Subject: **Response to Portion of NRC Request for Additional Information Letter No. 78 Related to ESBWR Design Certification Application – Gamma Thermometers - RAI Numbers 7.2-5 through 7.2-18 and 7.2-52 through 7.5-65**

**Response to Portion of NRC Request for Additional
Information Letter No. 78 Related to ESBWR Design
Certification Application**

Gamma Thermometers

Figure 1 (NRC RAI 7.2-8)

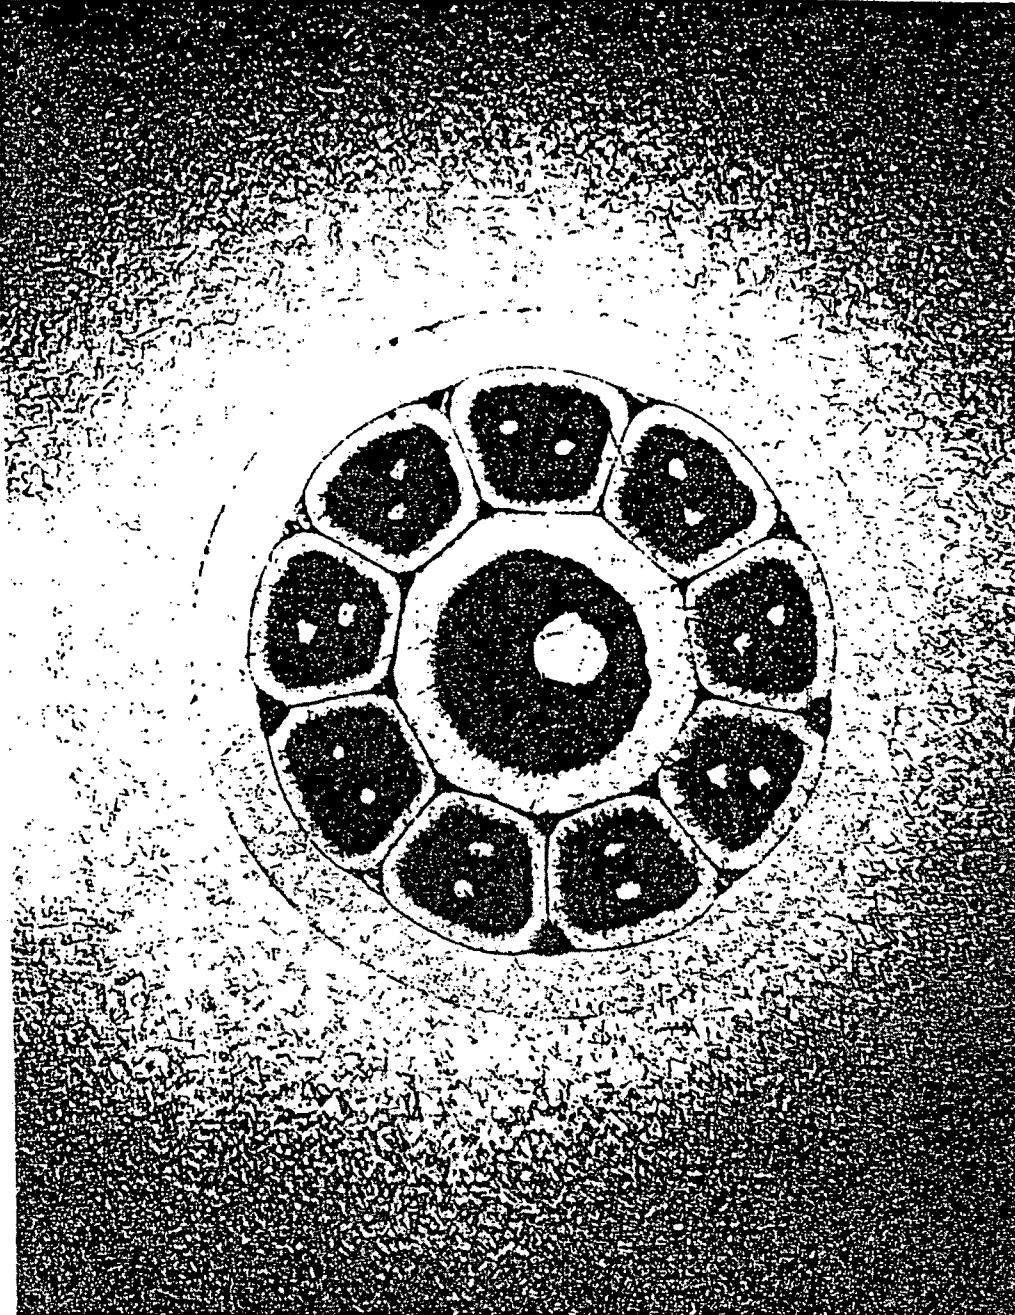
NRC RAI 7.2-8

Is the thermocouple medium within the cable pack a metal? Does the interface between the heater wire and medium produce a voltage as a result of dissimilar metals? Does the heater wire current during calibration, or possible interface voltages, impact the thermocouple signal?

The cable pack is a tightly compacted system consisting of the central heater cable and nine thermocouples (TC's) within the cable pack housing tube, seven of which are functional, see Figure 1, below. The heater cable and thermocouples each have a 316L SS sheath. The thermocouple thermoelements are isolated from the sheath by compacted high purity Al_2O_3 (see response to NRC RAI 7.2-5). The heater cable central heater, which is an 80 percent Ni, 20 percent chrome alloy, is coaxial and isolated from the sheath by high purity Al_2O_3 except at the far end where it is welded to the 316L SS sheath. The heater cable and thermocouple sheaths, as well as the gamma thermometer structure and LPRM, are at reactor ground potential.

When power is applied to the heater cable, a constant current of up to three amperes flows through the heater wire and is returned to the power supply common through the gamma thermometer (GT) structure. The thermocouple signal, developed as a result of heater cable power (as well as gamma heating at reactor conditions), is isolated from any heater cable voltage by the high purity Al_2O_3 insulation material which has an insulation resistance (IR) [[] or higher.

It is common practice to isolate both heater power and thermocouple measurement circuitry from reactor ground. Voltage present on the heater wire, to affect the thermocouple signal, would have to leak through the Al_2O_3 insulation to the heater cable and thermocouple sheaths, then through the thermocouple Al_2O_3 insulation to the thermoelements. At the sheaths it would encounter reactor ground which would effectively shunt it off from the thermocouples. Further, since the thermocouple measurement circuitry is isolated from reactor ground, if somehow a leakage voltage was present, there is no return current path from the heater wire to the thermocouple leads that could affect the thermocouple signal. Thus the thermocouple signal is isolated from any heater cable or related voltages.
